DECISION OF THE HEARINGS OFFICER

**VARIANCE / CLASS 3 SITE PLAN REVIEW / CLASS 2 ADJUSTMENT CASE
NO.: VAR-SPR-ADJ22-02**

SUMMARY: Proposed development of a new mixed-use building containing 71-dwelling units and 11,998 square feet of retail commercial floor area.

ANTHONY'S PLACE

SDR2

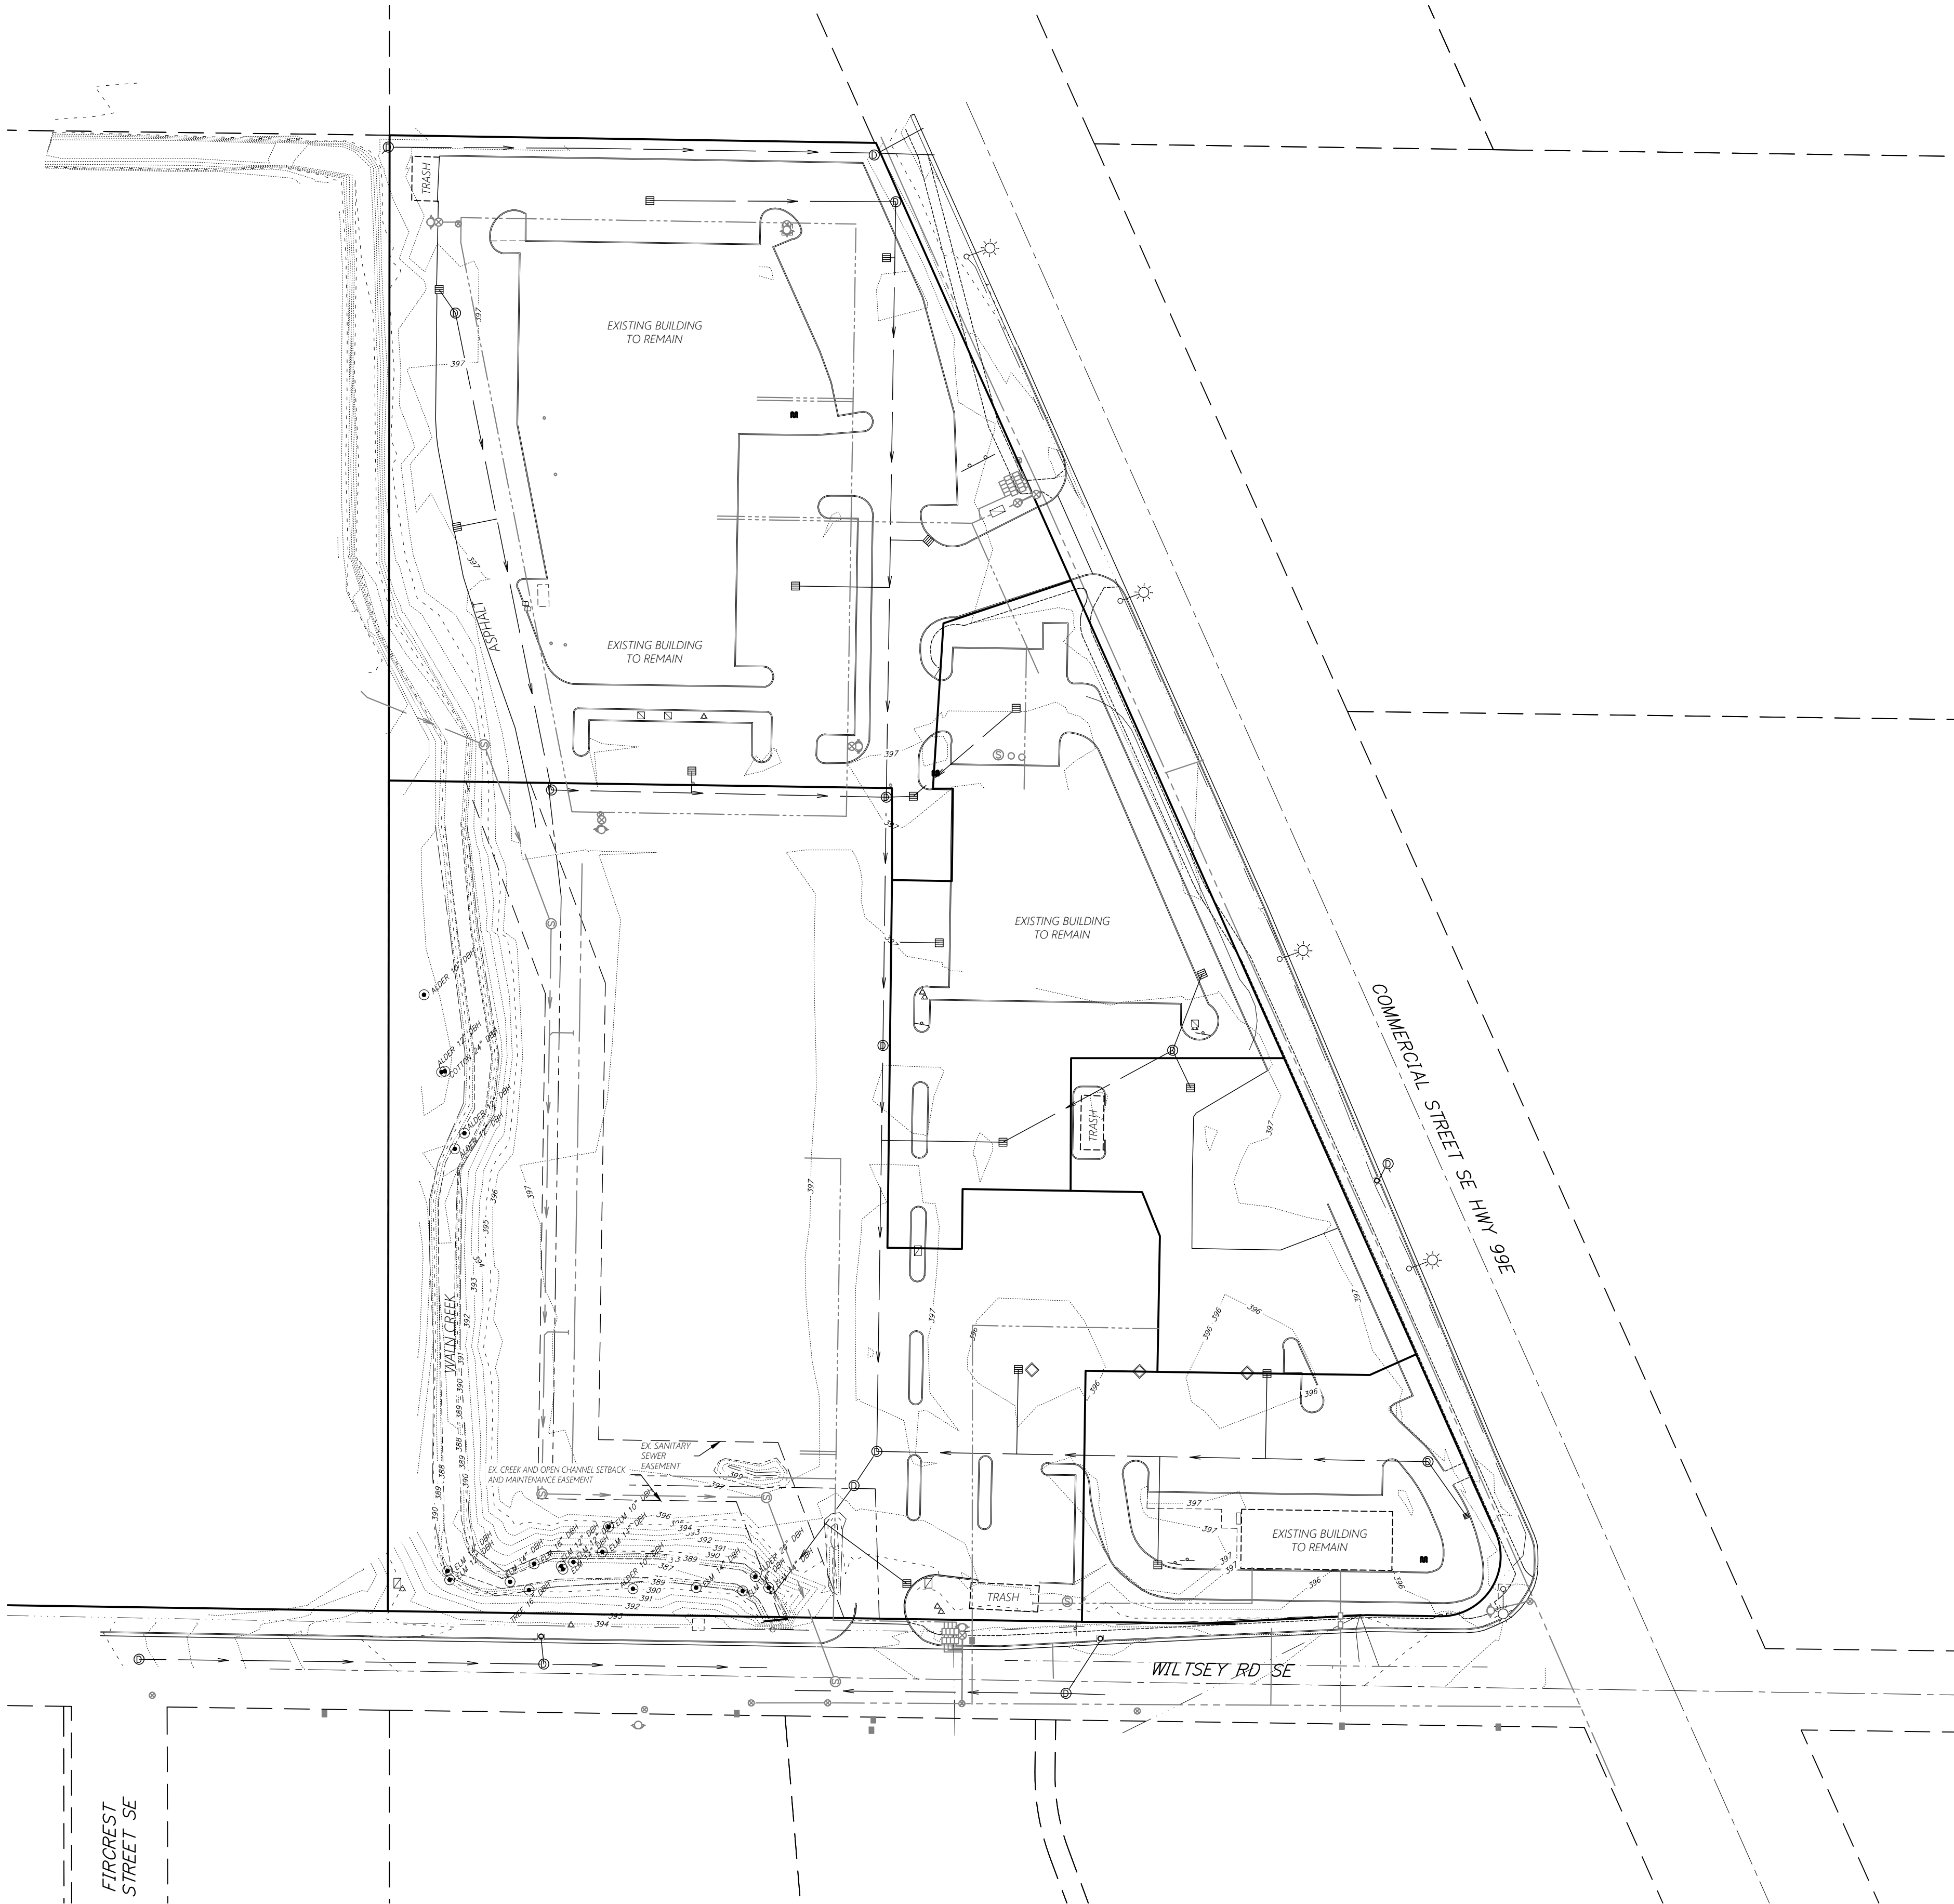
Finding: The applicant's existing conditions plan indicates that there are 20 trees on the subject property with no trees proposed for removal. The Hearings Officer concludes that the application satisfies this standard.

Waln Creek flows along the southern and western boundary of the subject property. The applicant's existing conditions plan shows 20 trees located on the subject property, with all trees proposed for preservation. No native vegetation within the riparian corridor of Waln Creek is proposed for removal.

SITE PLAN
1 TRASH / RECYCLE

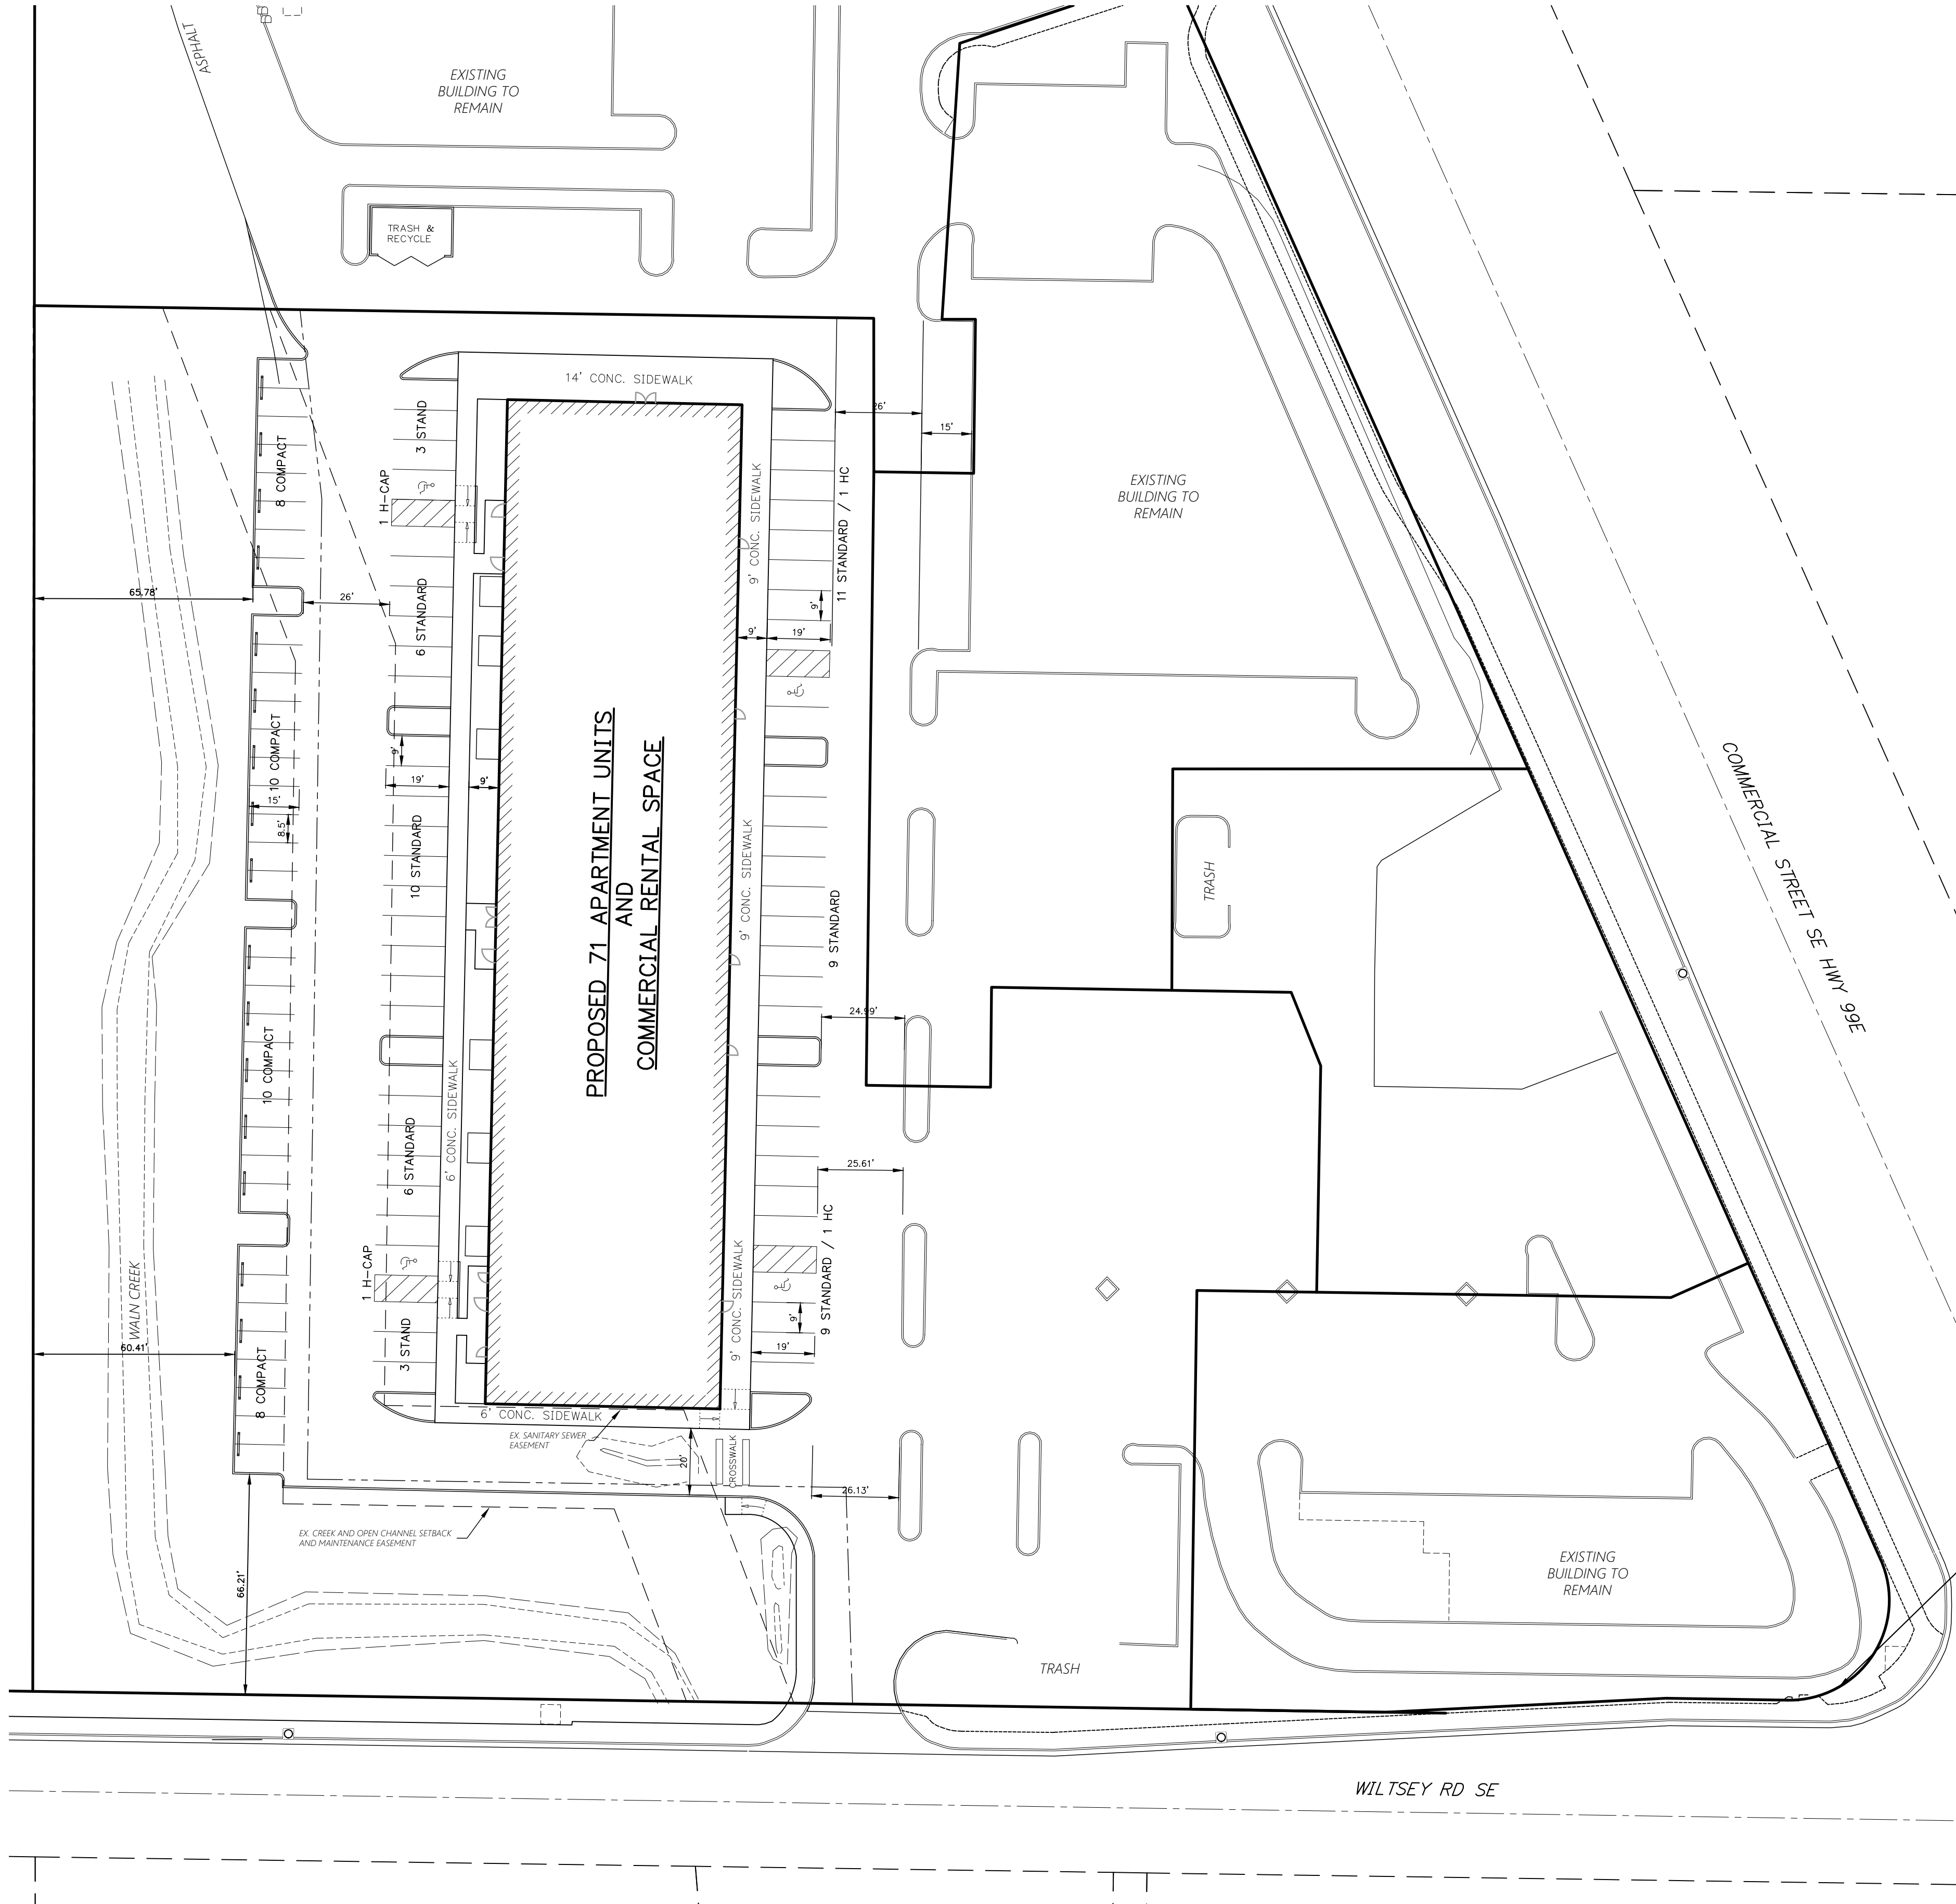
Finding: The site plan indicates that a new solid waste and recycling service area is provided at the southeast corner of the site near the water quality and detention basin. The following is a summary of applicable design standards for the solid waste and recycling service area:

Finding: The design and materials for the slab is not indicated in the proposed plans but will be reviewed for conformance with this development standard at the time of building permit review. The proposed enclosure is large enough that the receptacles may face each other with four feet or more of separation provided.

Finding: The enclosure has two openings approximately 12 feet in width, at the time of building permit review the applicant shall provide construction details verifying the front openings are a minimum of 12 feet in width in compliance with this provision. The Hearings Officer concludes that the application satisfies this standard.

Finding: The subject property abuts Wiltsey Road SE to the south; the site plan indicates that a pedestrian connection is provided between the primary building entrance and Wiltsey Road SE in compliance with this provision.

Finding: The proposed site plan does not show any pedestrian connections provided between the mixed-use building and the other existing buildings on the development site. The applicant has requested an adjustment to eliminate the requirement to provide pedestrian connections between buildings located on the same development site. Findings for the Adjustment request can be found in Section 8 of this decision. The Hearings Officer notes that the adjustment to eliminate the pedestrian connection to the current Taco Bell building is approved, so that the pedestrian connection will not end at the property line in the middle of the site.

Finding: Proposed pedestrian connections are five feet in width. The type of material proposed for the pedestrian connections is not listed in the application materials, and the method for protecting pedestrians adjacent to walkways is not clearly provided. In addition, with conditions of approval requiring revisions to the site plan at the time of building permit, including additional pedestrian pathways, it is not possible to determine compliance with this provision. At the time of building permit, the applicant shall demonstrate that all applicable standards of this section and SRC 800.065(c) are met.

The maximum off-street parking allowance is 1.75 times the minimum requirement, or 287 spaces ($191 \times 1.75 = 286.5$). There are currently 248 off-street parking spaces provided for the existing development site, the proposed site plan indicates that 95 new off-street parking spaces will be provided for a total of 344 off-street parking spaces which exceeds the maximum allowance for the development site.

Finding: The proposed off-street parking area is developed consistent with the additional development standards for grade, surfacing, and drainage. Bumper guards and wheel barriers are shown on the proposed site plan.

A minimum of 27 bicycle parking spaces are required for the proposed mixed-use building. Bicycle parking is not indicated on the site plan; however, the applicant's statement indicates that bicycle racks will be provided on site and located in convenient locations. At the time of building permit, the applicant shall demonstrate that the proposal complies with minimum bicycle parking requirements and all applicable development standards of SRC Chapter 806.

- Condition 3:** Development of the solid waste service areas shall conform to all applicable standards of SRC Chapter 800.
- Condition 4:** At the time of building permit, the applicant shall demonstrate that required pedestrian connections conform with the design and material requirements of SRC Chapter 800, specifically SRC 800.065(b)(1) and 800.065(c).

- Condition 5:** Prior to building permit approval the applicant shall provide an updated site plan and parking analysis demonstrating the off-street parking requirements of SRC Chapter 806 are met for the development site.

- Condition 6:** At the time of building permit, the applicant shall demonstrate that the proposal complies with minimum bicycle parking requirements and all applicable development standards of SRC Chapter 806.

Condition 5: Prior to building permit approval the applicant shall provide an updated site plan and parking analysis demonstrating the off-street parking requirements of SRC Chapter 806 are met for the development site.
